UNITED STATES PATENT AND TRADEMARK OFFICE

APPLICATION NO.	FILING DATE	FIRST NAMED INVENTOR	ATTORNEY DOCKET NO.	CONFIRMATION NO.
10/562,172	12/21/2005	Harald Koellner	40149/01001	1304
3636 7590 12/22/2010 FAY KAPLUN & MARCIN, LLP 150 BROADWAY, SUITE 702 NEW YORK, NY 10038				
EXAMINER STRIMBU, GREGORY J				
ART UNIT 3634		PAPER NUMBER		
MAIL DATE 12/22/2010		DELIVERY MODE PAPER

Office Action Summary

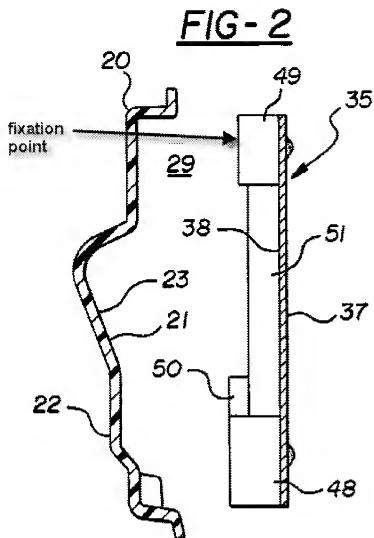
Claims 1, 2, 4-7, 12 are rejected under 35 U.S.C. 102(b) as being anticipated by Koa et al. (US 6412852). Koa et al. discloses a module for covering an opening (not numbered, but shown in figure 1) in a motor vehicle door 10 and for supporting a door inner trim 20, comprising: a base body 35 including a base 42 and at least one bracket 41 movable with respect to the base, the bracket 41 including a supporting surface 37 for contacting an edge region surrounding the opening, the bracket including at least one fixation point (labeled below) for fastening only to a door inner trim 20, and fixation elements 49, 51 for fastening only the module on an edge region of the opening, wherein the fixation elements and the at least one bracket are laterally offset from each other with respect to a plane defined by the module;

regarding claim 2, the module includes a sheet 35 of one of a metal and a plastic (see column 5, lines 41-43);

regarding claim 4, a peripheral seal 45 limiting the passage of moisture through the opening;

regarding claim 5, the bracket 41 is integrally formed on the base body 42;

regarding claim 6, the bracket 41 is coupled to the base by a film hinge 40;

regarding claim 7, the bracket 41 includes a clipping opening 39 sized to receive and clip therein a corresponding part 25 of the inner trim 20;

regarding claim 11, the bracket is fastened to the base by at least one spring element 40;

regarding claim 12, a plurality of fixation elements 25 fastening the module to the edge of the opening.

Fig. 4

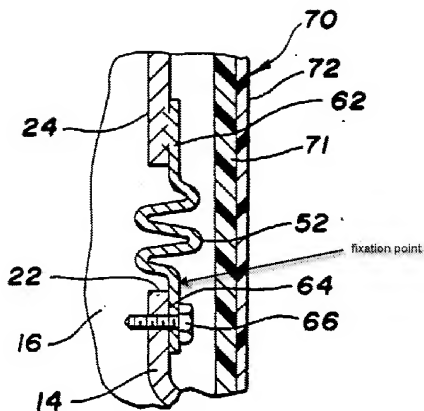
Claims 1, 2, 5, 6, 8, 9 and 11-14 are rejected under 35 U.S.C. 102(b) as being anticipated by Lau et al. (US 5048234). Lau et al. discloses a module 24 for covering an opening 22 in a motor vehicle door and for supporting a door inner trim 70, comprising: a base body including a base 24 and at least one bracket 52 movable with respect to the base, the bracket including a supporting surface (not numbered, but shown in figure 4) contacting an edge region surrounding the opening, the bracket including at least one fixation point (labeled below) for fastening only to the door trim 70, and fixation elements (not shown, but comprising the portions of the base 24 that overlap the inner panel 14 as set forth in column 3, lines 4-6) for fastening only the module on an edge region of the opening, wherein the fixation elements and the at least one bracket 52 are laterally offset from each other with respect to plane defined by the module as shown in figure 4;

regarding claim 6, the bracket 52 is coupled to the base by a film hinge (not numbered, but shown in figure 4);

regarding claim 11, the bracket 52 is fastened to the base 24 by at least one spring element (not numbered, but shown in figure 4);
